VIEW A-A
3 PLACES, TYPICAL

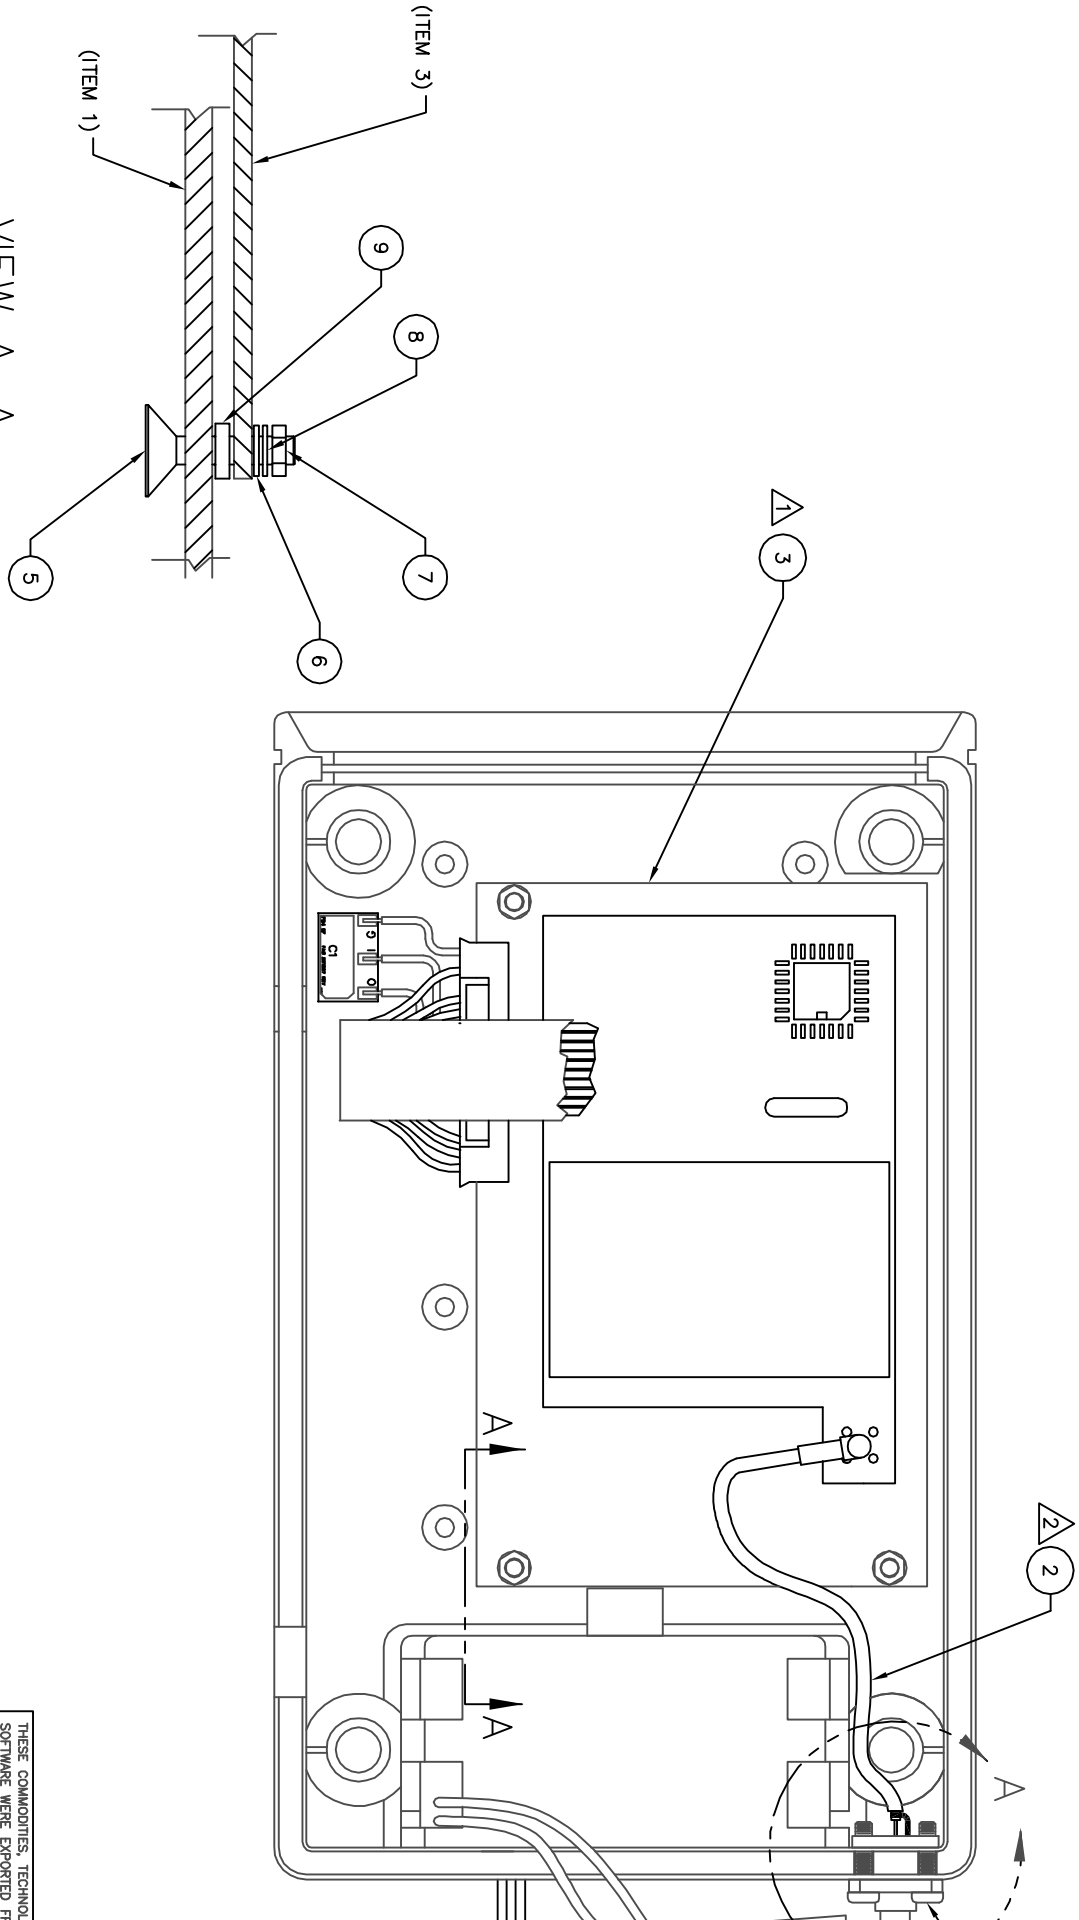
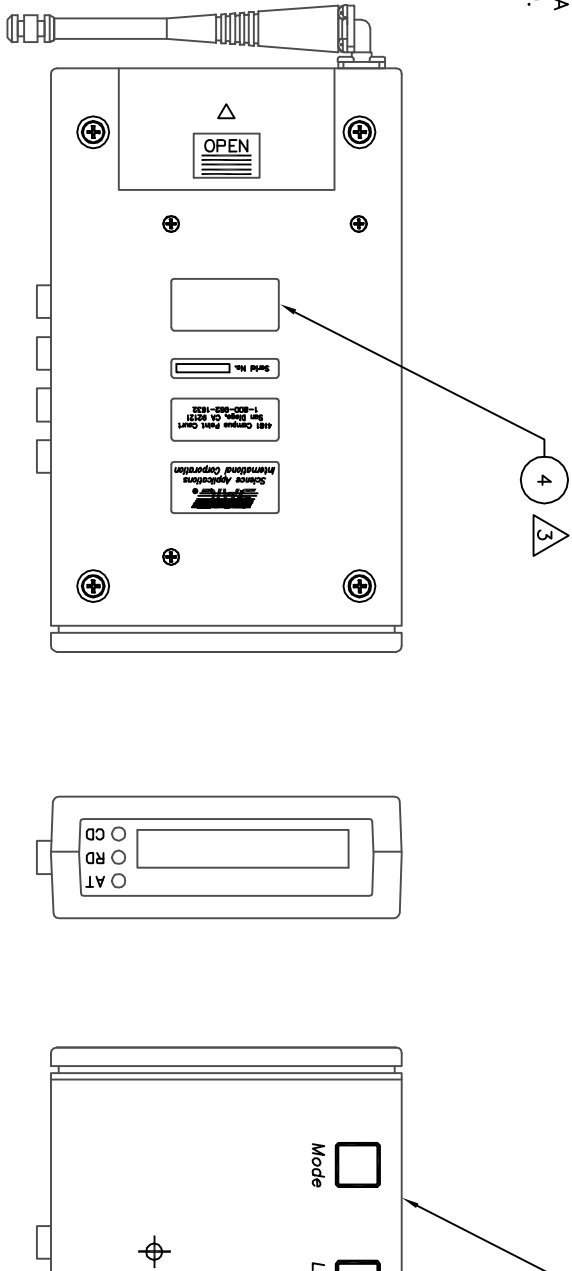
REMOVE EXISTING PROXIM WIRELESS MODEM AND MOUNTING HARDWARE. REPLACE WITH ITEM 3, PDE-5 PWA PDE-5 PWA AND MOUNTING HARDWARE, ITEMS 5 THRU 9. SEE VIEW A-A, PAGE 2.
- 2

REMOVE EXISTING RF CABLE AND REPLACE WITH ITEM 2, RF CABLE. ROUTE CABLE AS SHOWN.
- 3

APPLY FCC LABEL, ITEM 4 OVER THE EXISTING FCC LABEL.
- 4

REMOVE EXISTING CONNECTOR & ANTENNA AND REPLACE WITH ITEMS 11 & 12, AS SHOWN.
- 5

SOLDER 1AW J-STD-001, CLASS 2, USING ITEM 10.
